Staff Report

To: Salt Lake City Historic Landmark Commission
From: Anthony Riederer
801-535-7625 or anthony.riederer@slcgov.com
Date: April 7, 2016
Re: PLNHLC2015-00967 – New Construction in a Historic District
PLNHLC2016-00176 – Demolition of Non-Contributing Structures

NEW CONSTRUCTION AND DEMOLITION OF NON-CONTRIBUTING STRUCTURES

PROPERTY ADDRESS: Approximately 740 South 700 East
PARCEL ID: 16-08-105-016 and 16-08-105-015
HISTORIC DISTRICT: Central City Local Historic District
ZONING DISTRICT: RMF-30 (Residential Multi-Family, Low Density)
MASTER PLAN: Central Community Master Plan

PROPOSED SITE PLAN
1" = 10'-0"

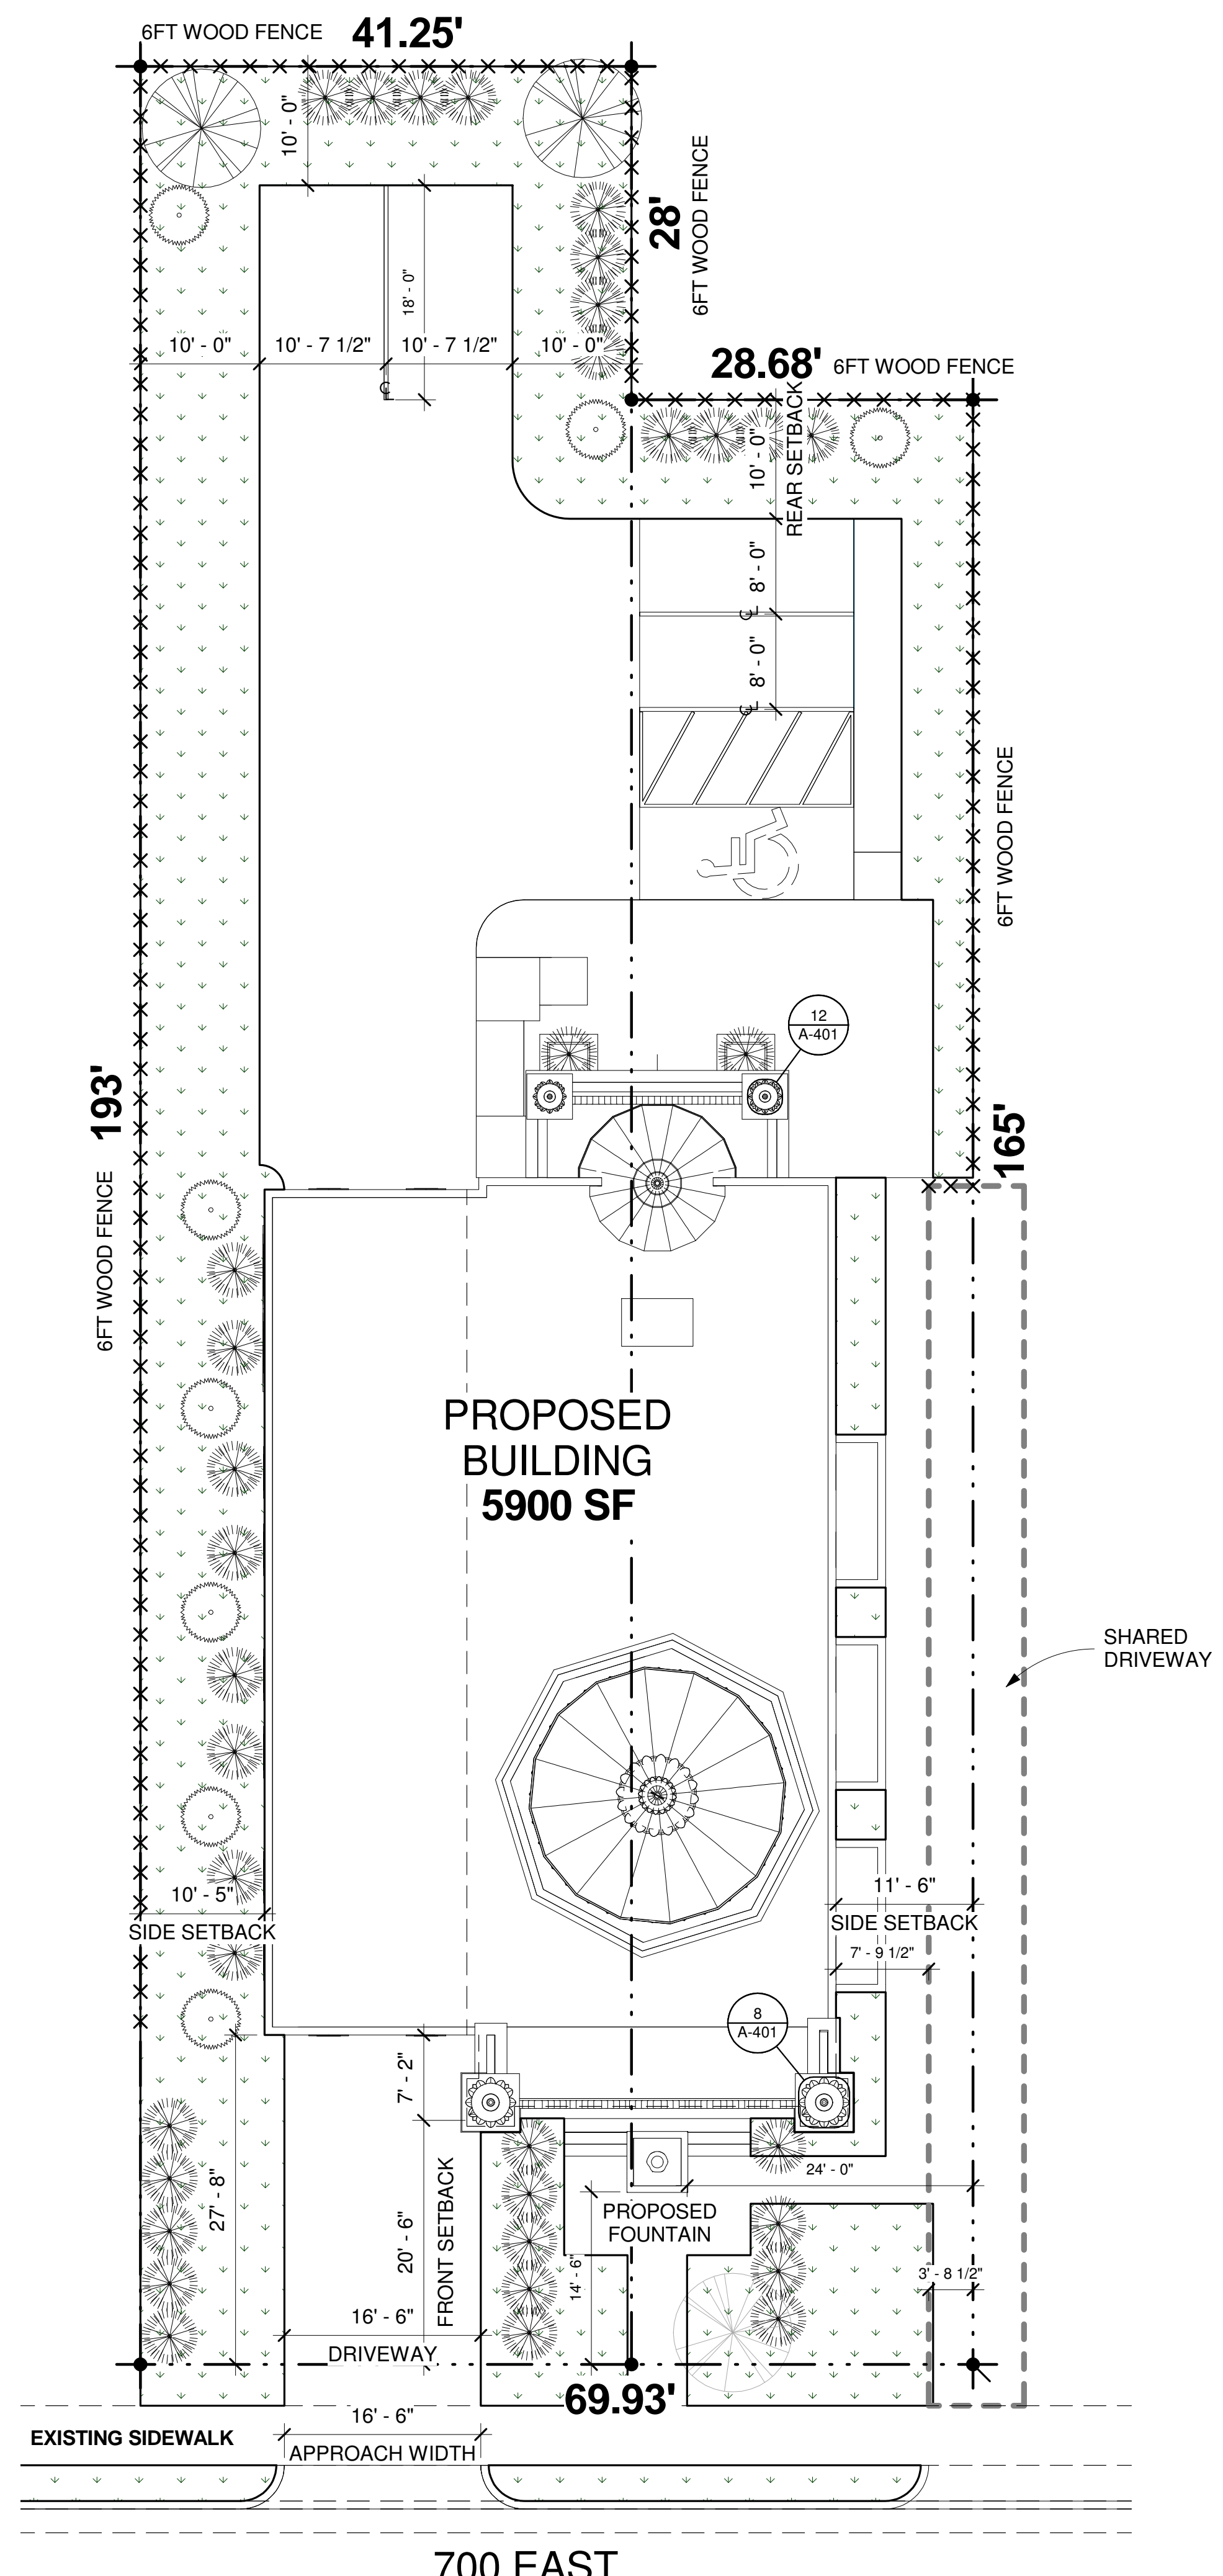
Upon reviewing the proposed site design, Salt Lake City's Transportation Division identified two areas that need to be revised to comply with city codes.

- 1) There are two parking stalls that are indicated as measuring 8' across. The minimum size for a parking stall is 8'3".
 - 2) The site is required to provide bike rack as per 21A.44.050(B)(4).
- This issue has been addressed as a proposed condition of approval.

1. There are two parking stalls that are shown as 8 feet wide; the minimum width is 8 feet 3 inches (8' 3"). We need 3 more inches added to each stall. The ADA parking space and the ADA parking aisle can be 8 feet each.
2. One bike rack is required; see 21A.44.050.B.4 for location requirements. See Standard Detail F1.f2, "Bicycle Rack", for installation standards online at: <http://www.slcdocs.com/transportation/design/pdf/F1.f2.pdf>.

ELEVATIONS

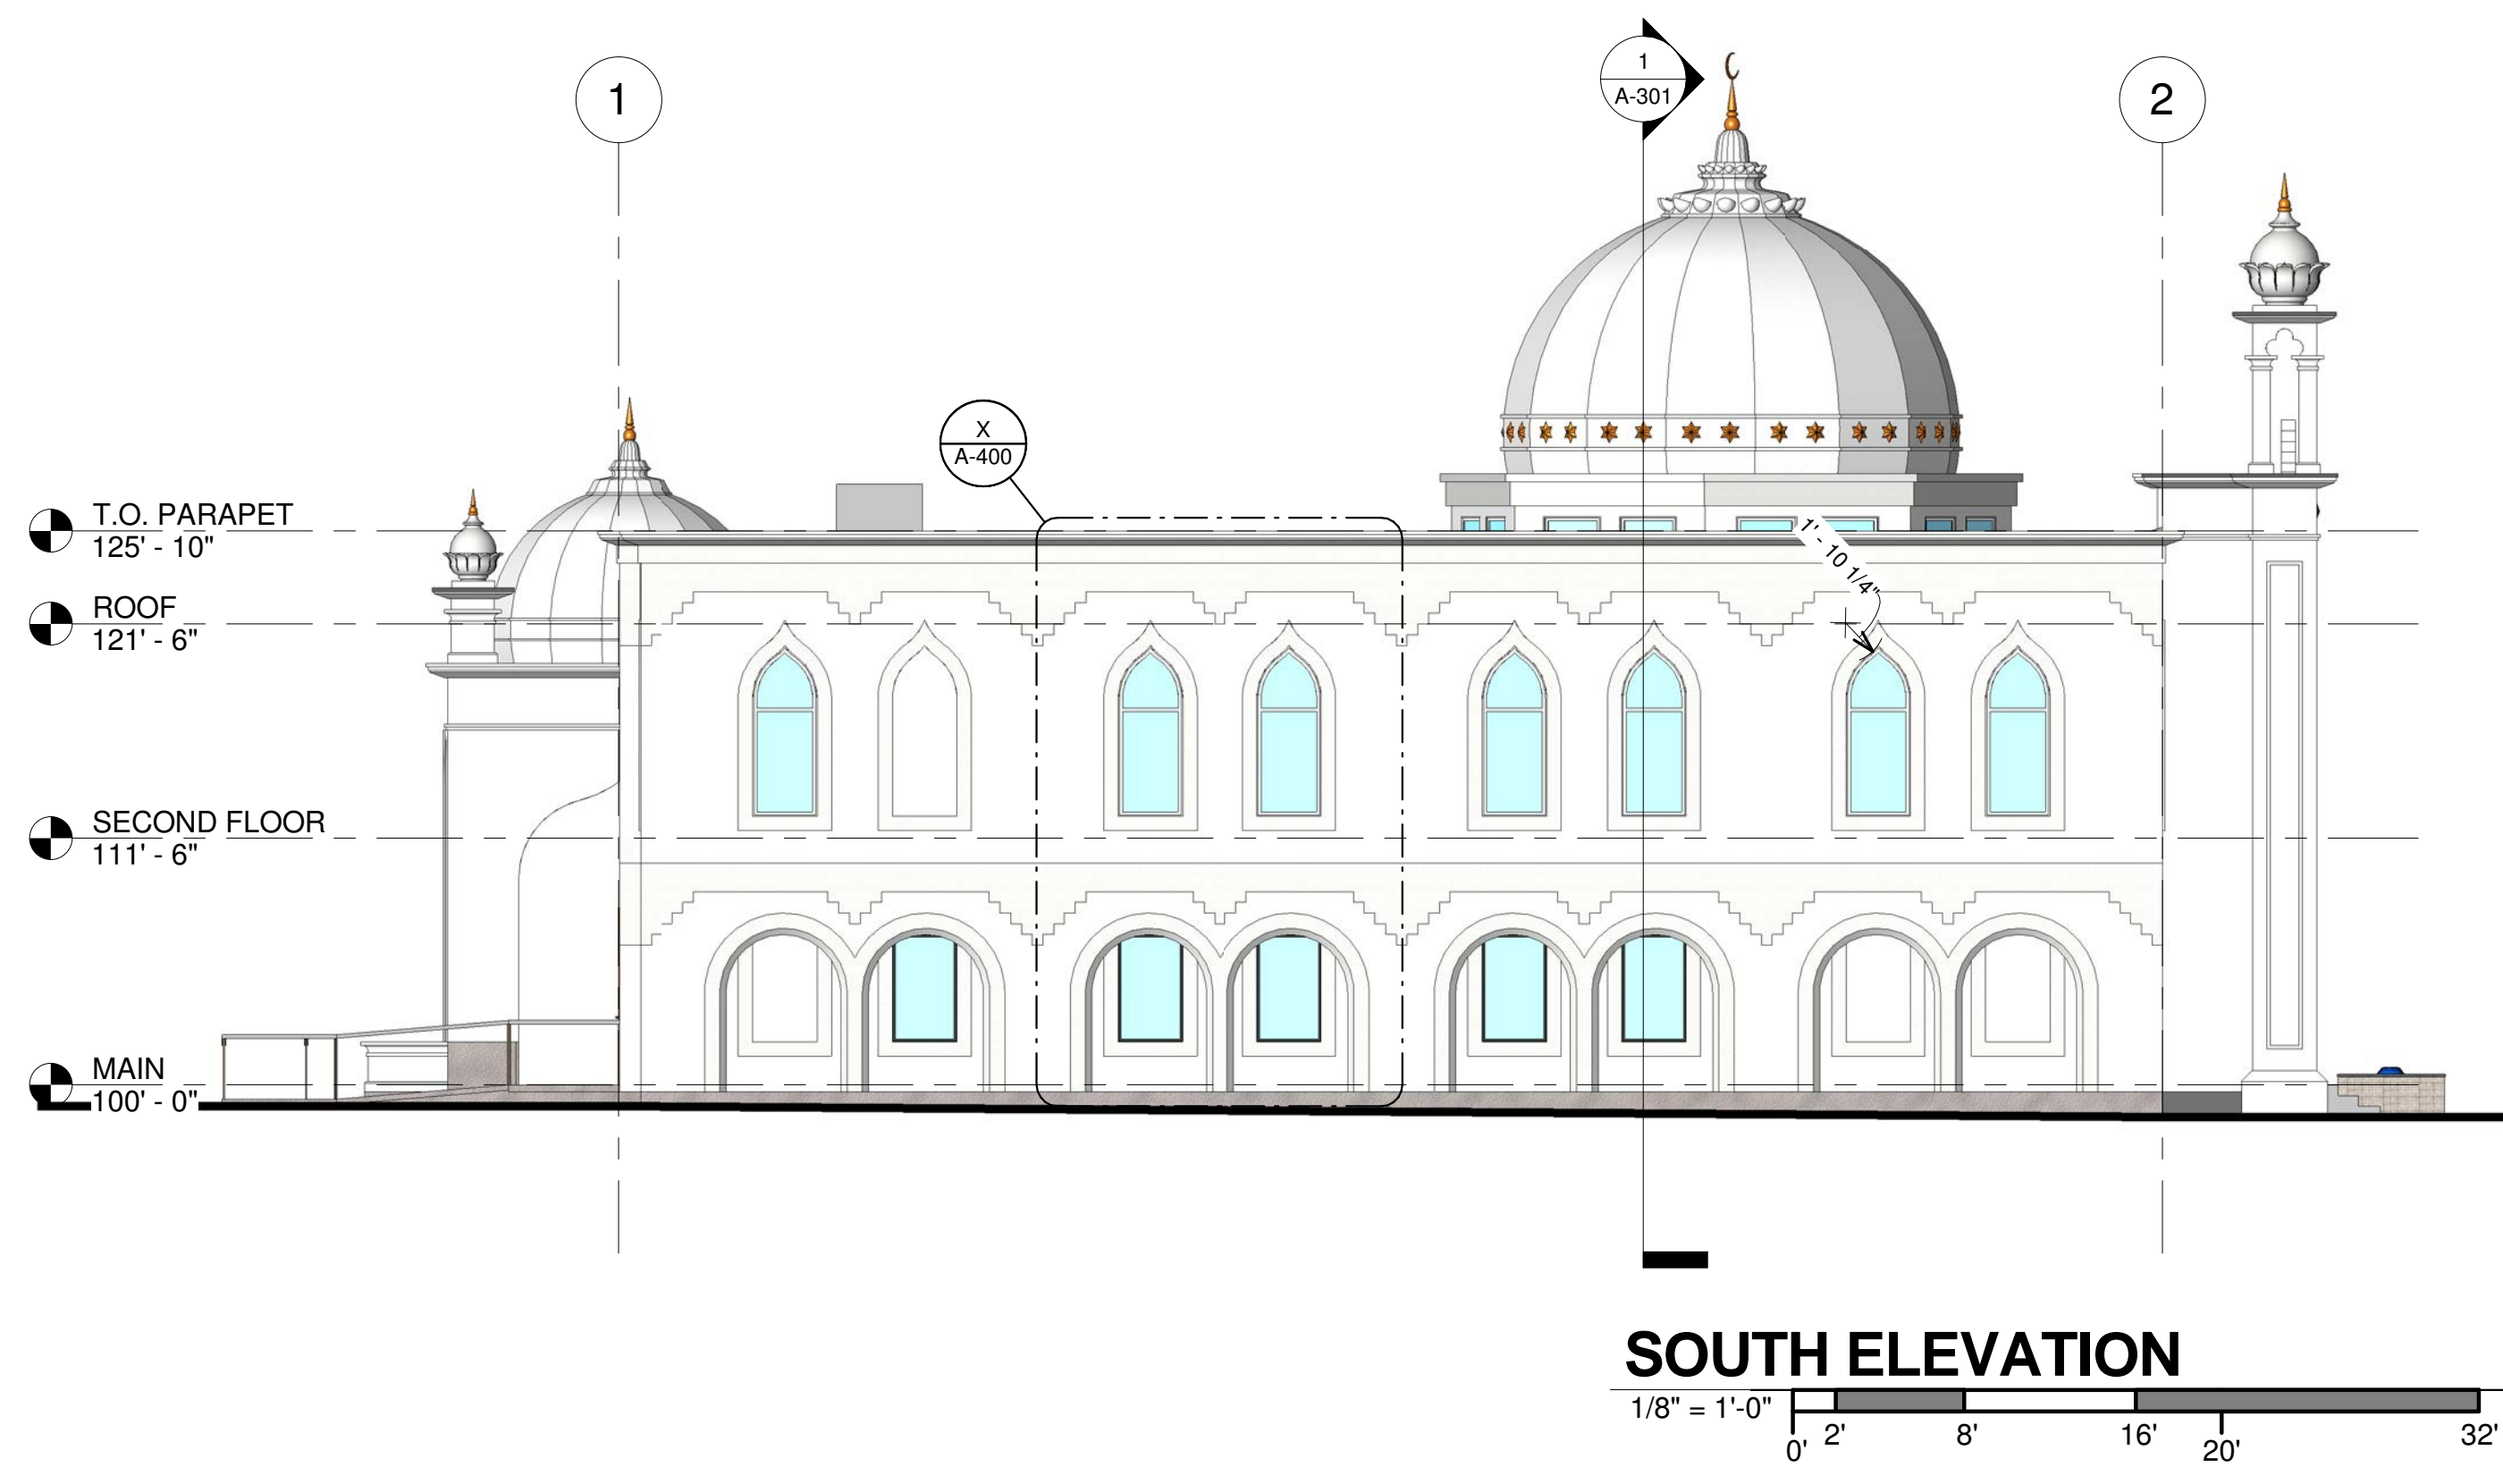
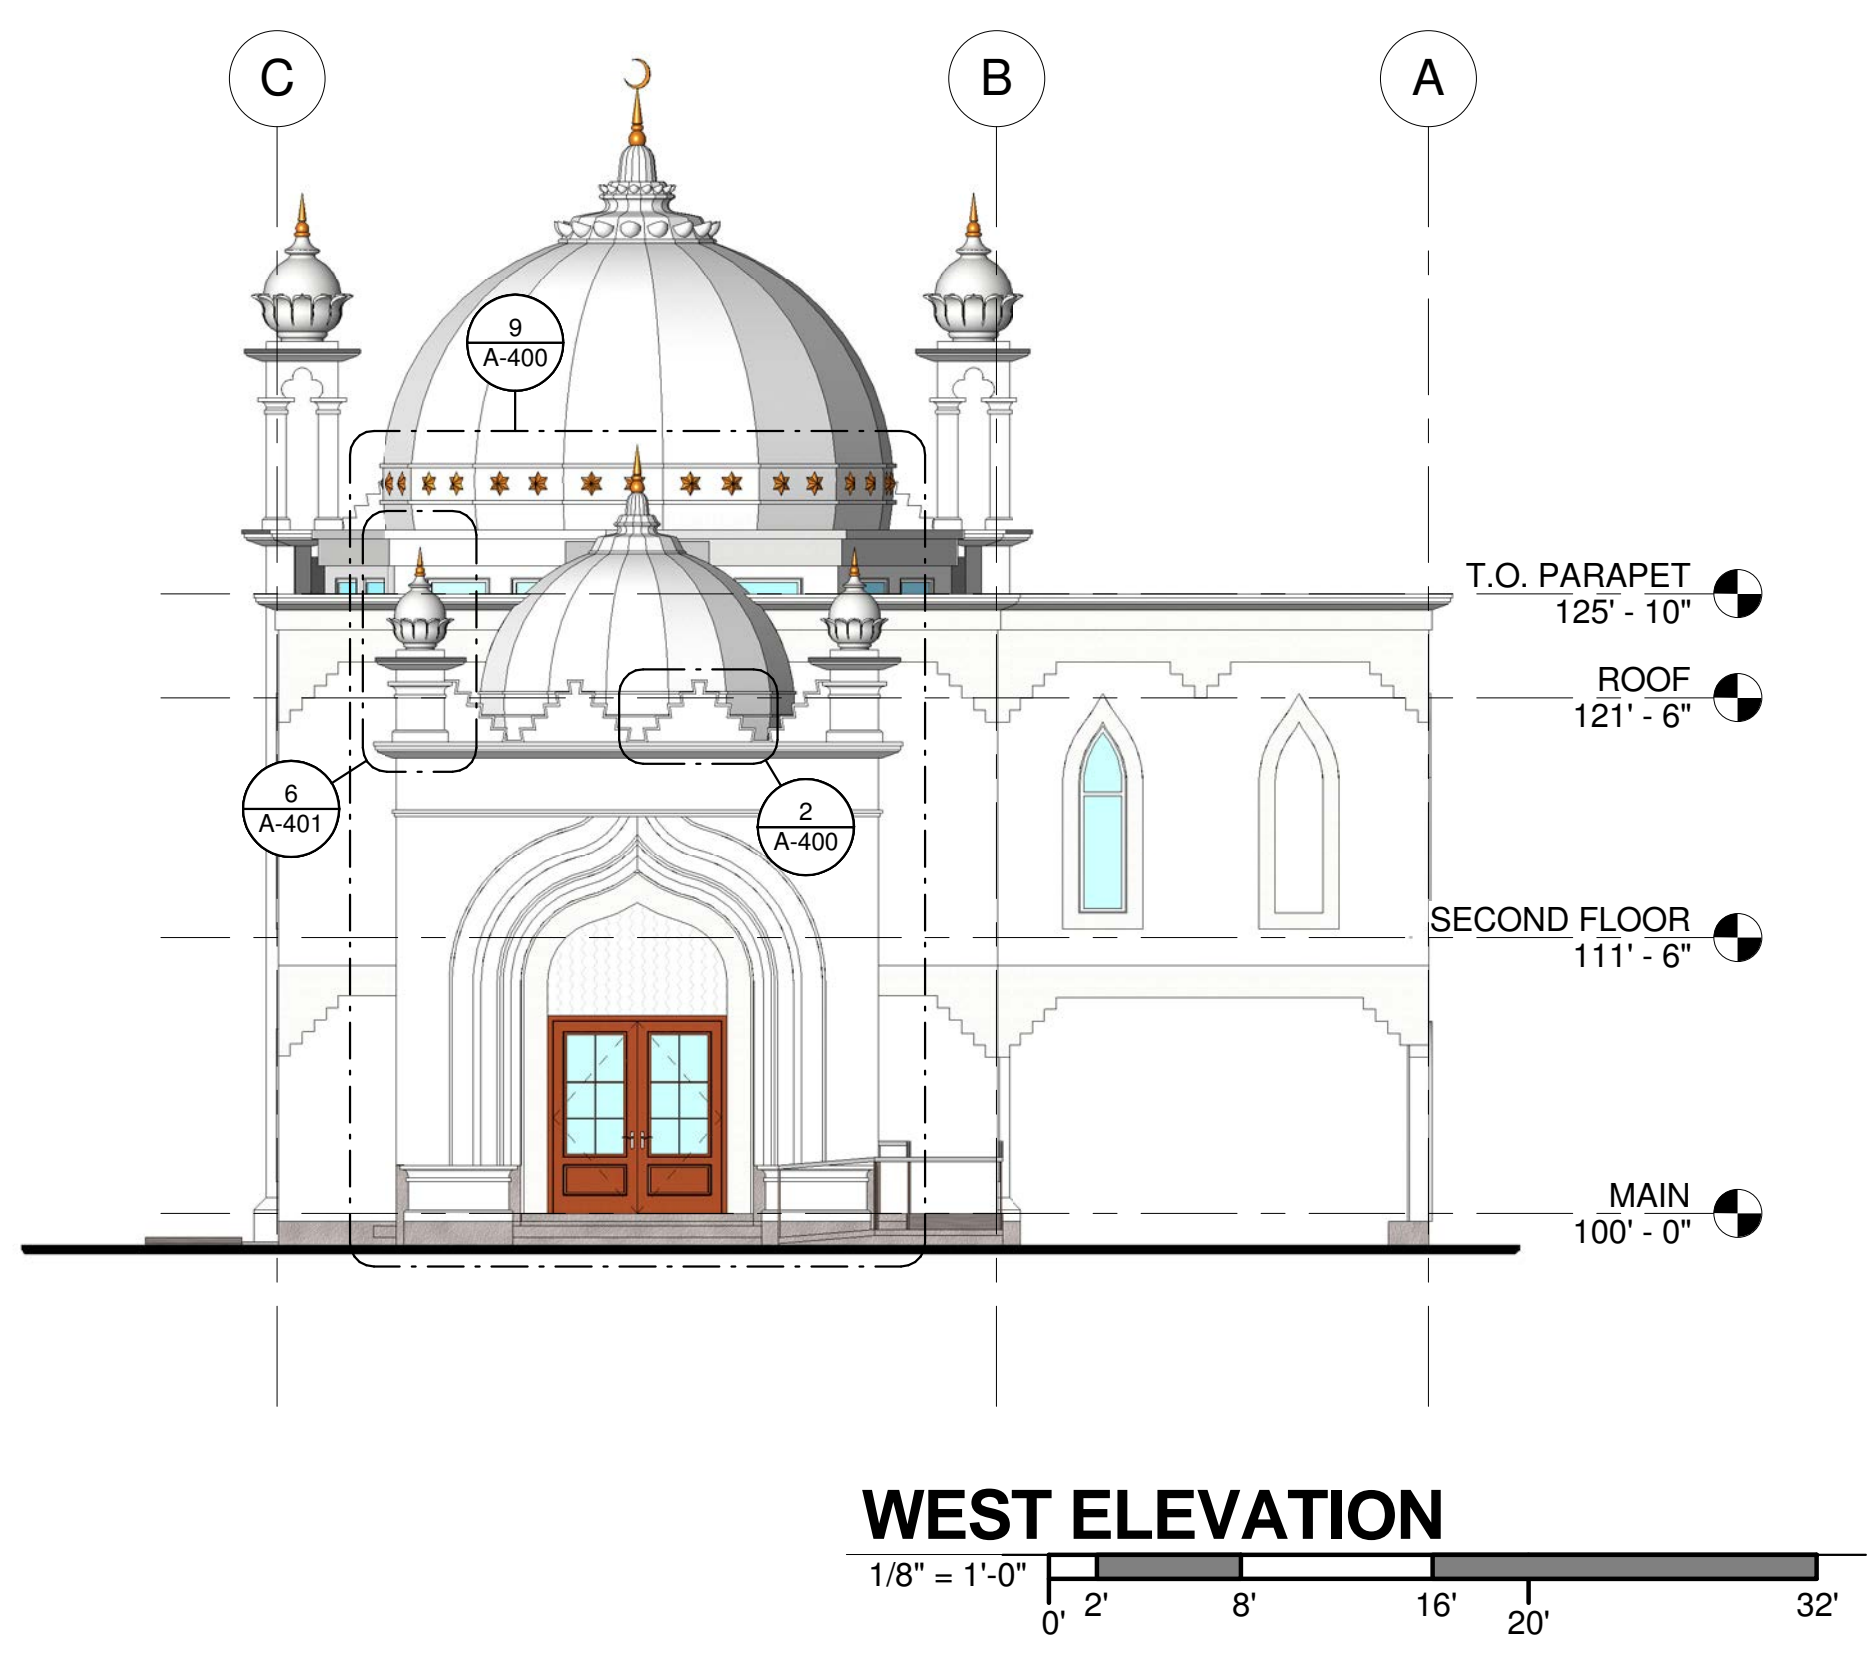
Issue 1: Depth and Dimensionality of Window Reveals

Frequently, on historic buildings, windows are somewhat recessed into a façade allowing shadows to help create dimensionality along the façade. There are a number of windows on each façade of the building and, given its scale, many will be particularly visible from the public way. Although care has been taken in the proposed design to outline windows with differentiated and complimentary surrounds, they sit fairly close to the plane of the façade. This forestalls the possibility for the creating of shadows and hence the articulation common to other buildings in the district.

Issue 4: Façade Materials

Much of the exterior of the proposed building is intended to be composed of hard coat stucco. Though this is a material commonly found throughout the Central City district, the proposed design offers a significant amount of it in a single building.

- 1) Depths of window reveals are revised to provide improved façade articulation.
- 2) The site plan is revised to accord with project review comments received from Salt Lake City's Transportation Division.
- 3) The lots are consolidated into a single parcel.
- 4) The design complies with all applicable building and development codes.
- 5) Approval of final design details are delegated to staff for approval.
